GUYONG QUARRY – DETAILED RESPONSE TO PUBLIC EXHIBITION SUBMISSIONS

Submitted by NSW Government Office of Water (NOW) 12 November, 2009

Figure 1- RME, naturally occurring asbestos pit and mapping locations for the proposed quarry site.

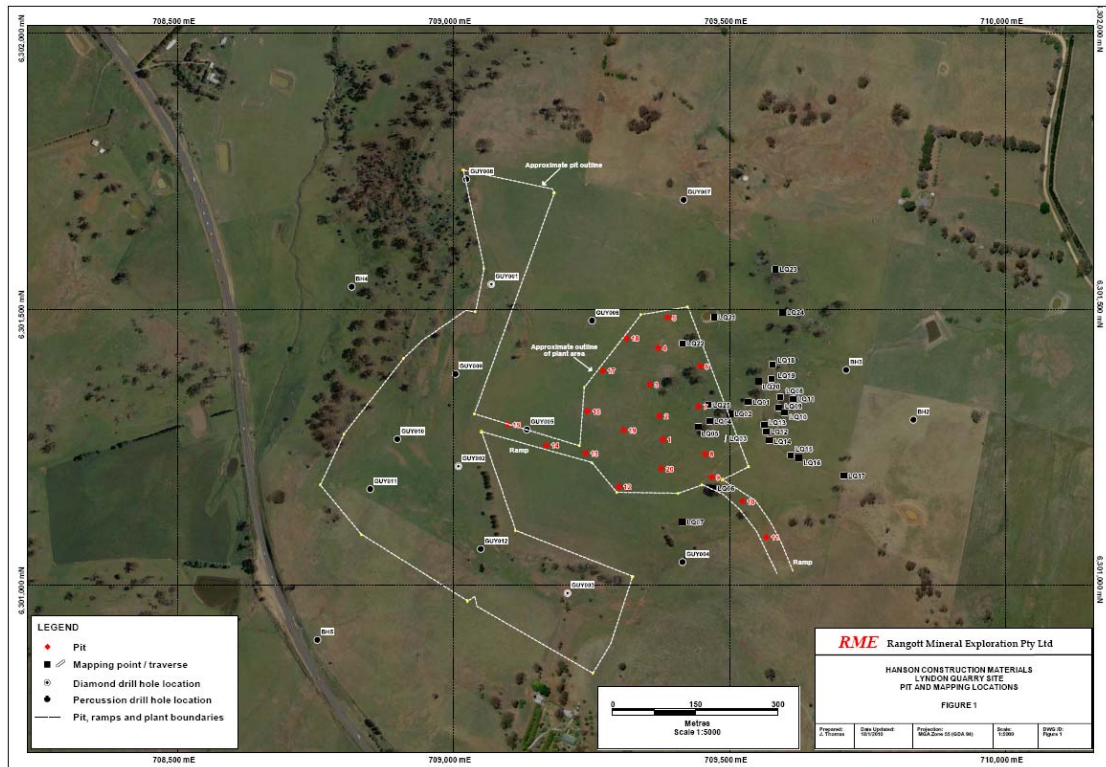
The study involved geological mapping and sampling (on the surface, excavator dug pits, and examination of core holes) of the areas within and around the development envelope of the proposed quarry (see figure 1 below). The report concluded that the basalt in the proposed extraction quarry pit, where drilling and blasting will occur, does not contain asbestos. Based on this the risk associated with exposure to asbestos due to drilling and blasting within the quarry pit is negligible. The RME report indicates that the risk of encountering asbestos increases further to the east away from the extraction area. The RME report has classified the areas of risk as shown in figure 2 below. In the western half of the proposed processing plant and stockpile area, there is an increasing thickness of cover of partly to deeply weathered Tertiary basalt. This cover material is unlikely to contain asbestiform minerals, except where mixing of Ordovician and Tertiary rock rubble may have occurred in the past. Tremolite asbestos has been detected in the Byng Volcanics rocks that are exposed sporadically along the eastern quarter of the proposed plant site, and for at least 150 metres to the east of the eastern boundary of the plant, and in all probability, are exposed much further to the east.

- Excavating subsoil and clayey weathered Tertiary Basalt and Scree rocks from the western side of proposed plant site and connecting ramp to quarry pit and placing it over the eastern side of the plant site and compacting it **providing a safe cover of 1-2m over the high risk zone.**
- Excavation of the larger water storage dam retention pond will require constant wetting down of work areas. Wearing of appropriate dust masks in the work areas and downwind during this activity. The filters in air conditioning units on plant equipment should be fitted with filters to prevent fine asbestos fibres from entering the cabins, and washing down plant and equipment on completion of the dam construction will be necessary.
- The entire finished dams should be covered with a thin layer of subsoil or clay, overlain by a thin layer of topsoil, and vegetated with durable binding pasture.

Figure 1- RME, naturally occurring asbestos pit and mapping locations for the proposed quarry site.

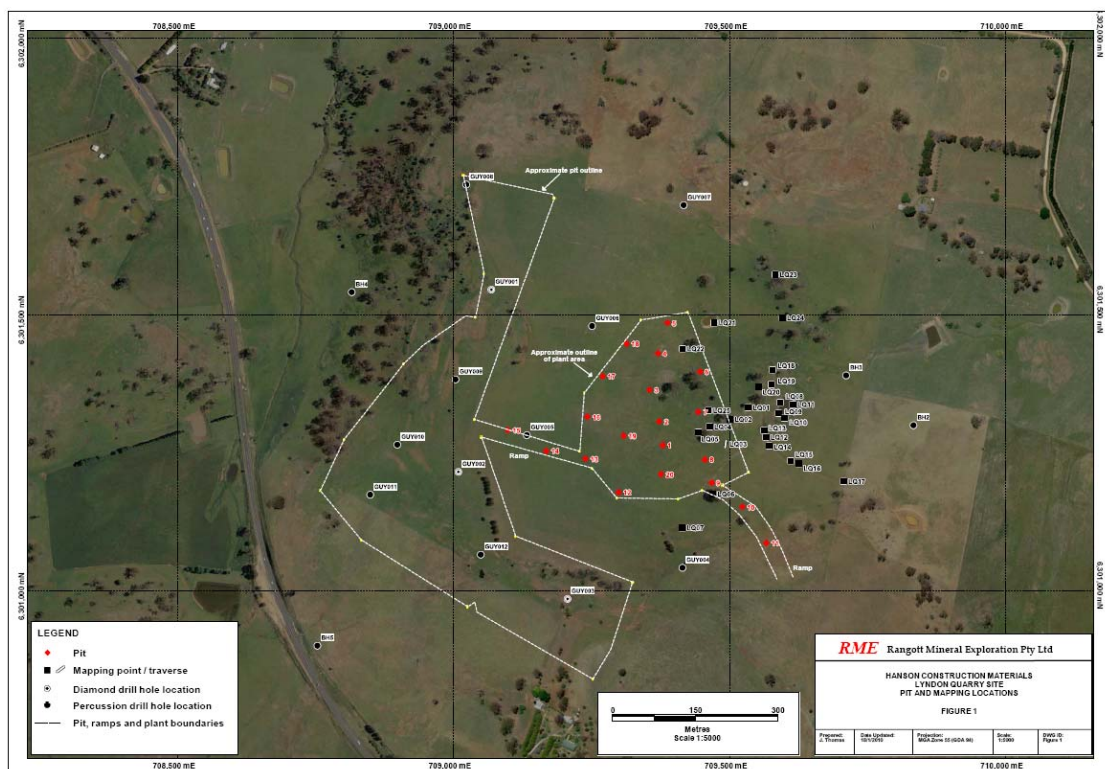
The study involved geological mapping and sampling (on the surface, excavator dug pits, and examination of core holes) of the areas within and around the development envelope of the proposed quarry (see figure 1 below). The report concluded that the basalt in the proposed extraction quarry pit, where drilling and blasting will occur, does not contain asbestos. Based on this the risk associated with exposure to asbestos due to drilling and blasting within the quarry pit is negligible. The RME report indicates that the risk of encountering asbestos is increase further to the east away from the extraction area. The RME report has classified the areas of risk as shown in figure 2 below. In the western half of the proposed processing plant and stockpile area, there is an increasing thickness of cover of partly to deeply weathered Tertiary basalt. This cover material is unlikely to contain asbestiform minerals, except where mixing of Ordovician and Tertiary rock rubble may have occurred in the past. Tremolite asbestos has been detected in the Byng Volcanics rocks that are exposed sporadically along the eastern quarter of the proposed plant site, and for at least 150 metres to the east of the eastern boundary of the plant, and in all probability, are exposed much further to the east.

- Excavating subsoil and clayey weathered Tertiary Basalt and Scree rocks from the western side of proposed plant site and connecting ramp to quarry pit and placing it over the eastern side of the plant site and compacting it **providing a safe cover of 1-2m over the high risk zone.**
- Excavation of the larger water storage dam retention pond will require constant wetting down of work areas. Wearing of appropriate dust masks in the work areas and downwind during this activity. The filters in air conditioning units on plant equipment should be fitted with filters to prevent fine asbestos fibres from entering the cabins, and washing down plant and equipment on completion of the dam construction will be necessary.

- The entire finished dams should be covered with a thin layer of subsoil or clay, overlain by a thin layer of topsoil, and vegetated with durable binding pasture.

Figure 1- RME, naturally occurring asbestos pit and mapping locations for the proposed quarry site.

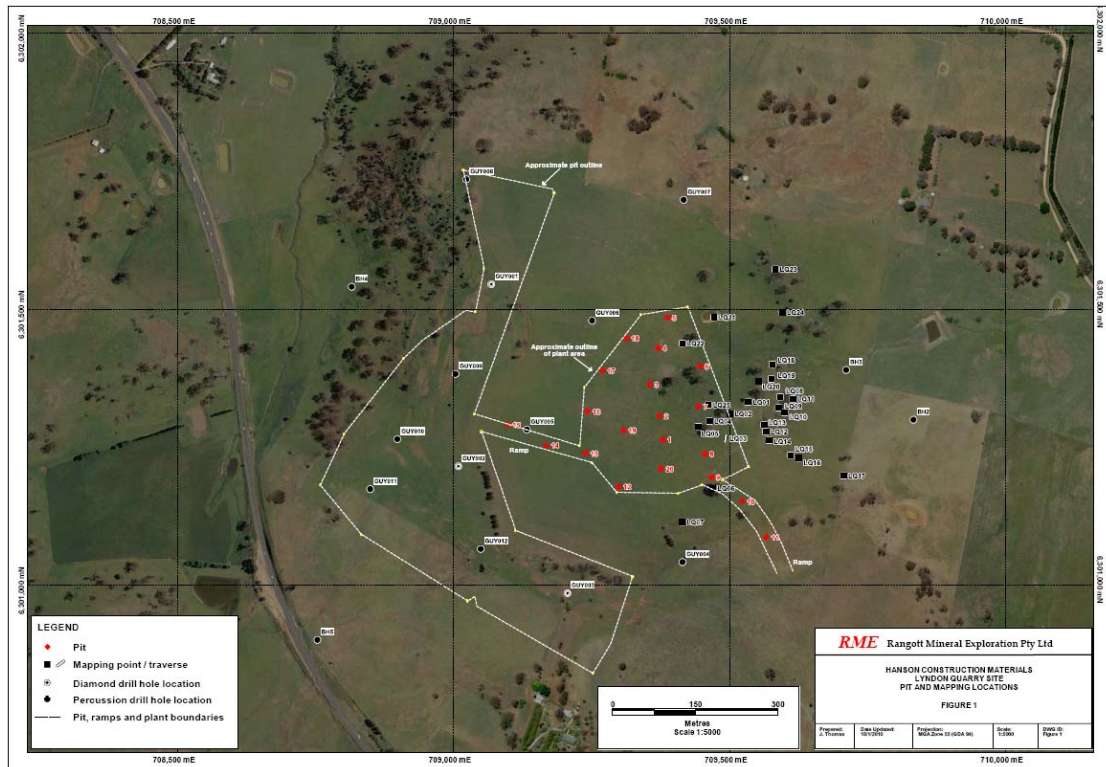
The study involved geological mapping and sampling (on the surface, excavator dug pits, and examination of core holes) of the areas within and around the development envelope of the proposed quarry (see figure 1 below). The report concluded that the basalt in the proposed extraction quarry pit, where drilling and blasting will occur, does not contain asbestos. Based on this the risk associated with exposure to asbestos due to drilling and blasting within the quarry pit is negligible. The RME report indicates that the risk of encountering asbestos increases further to the east away from the extraction area. The RME report has classified the areas of risk as shown in figure 2 below. In the western half of the proposed processing plant and stockpile area, there is an increasing thickness

of cover of partly to deeply weathered Tertiary basalt. This cover material is unlikely to contain asbestiform minerals, except where mixing of Ordovician and Tertiary rock rubble may have occurred in the past. Tremolite asbestos has been detected in the Byng Volcanics rocks that are exposed sporadically along the eastern quarter of the proposed plant site, and for at least 150 metres to the east of the eastern boundary of the plant, and in all probability, are exposed much further to the east.

- Excavating subsoil and clayey weathered Tertiary Basalt and Scree rocks from the western side of proposed plant site and connecting ramp to quarry pit and placing it over the eastern side of the plant site and compacting it **providing a safe cover of 1-2m over the high risk zone.**
- Excavation of the larger water storage dam retention pond will require constant wetting down of work areas. Wearing of appropriate dust masks in the work areas and downwind during this activity. The filters in air conditioning units on plant equipment should be fitted with filters to prevent fine asbestos fibres from entering the cabins, and washing down plant and equipment on completion of the dam construction will be necessary.
- The entire finished dams should be covered with a thin layer of subsoil or clay, overlain by a thin layer of topsoil, and vegetated with durable binding pasture.
